ALERT SERVICE BULLETIN

412-21-185

- MODEL AFFECTED:** 412/412EP
- SUBJECT:** TAIL ROTOR DRIVE SHAFT ASSEMBLY 412-040-620-103 INSPECTION AND REMOVAL FROM SERVICE
- HELICOPTERS AFFECTED:** Serial numbers 34025 through 34036, 36020 through 36687, 36689 through 36999, 37002 through 37018, 37021 through 37051 and helicopters with upgrade kit 412-704-052 installed per BHT-412-SI-74 or modified in accordance with drawing 412-570-001 or 412-706-100 (412SP to HP upgrade).

Figure 1. Location of part and serial numbers

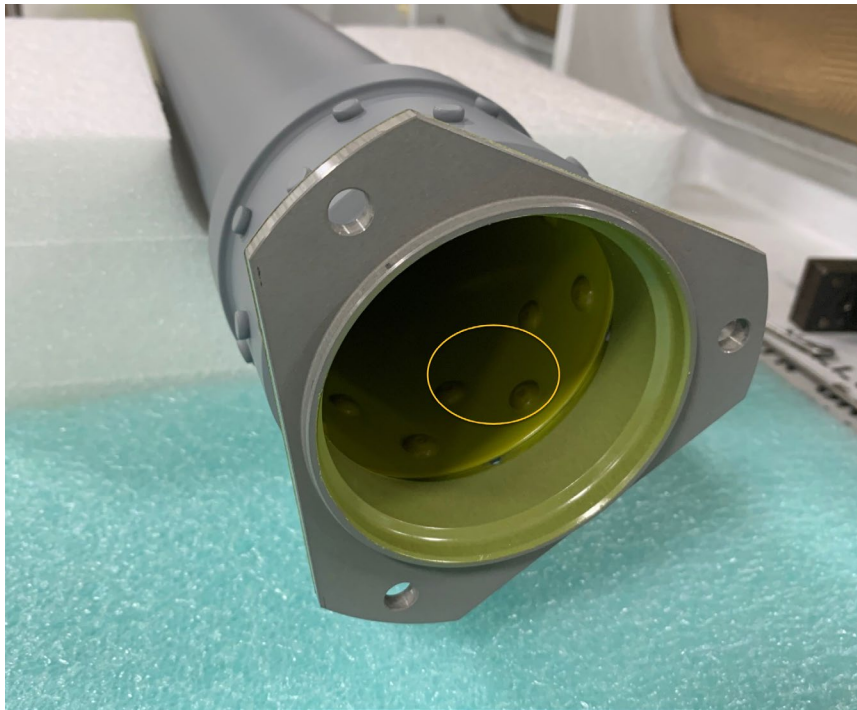
3. Verify the serial number of the tail rotor drive shaft assembly installed on the helicopter. The drive shaft assembly part number and serial number are located on the flange of the drive adapter attached to the intermediate gearbox (refer to Figure 1) Do not confuse drive adapter 412-040-623-101 serial number with the drive shaft assembly 412-040-620-103 serial number.
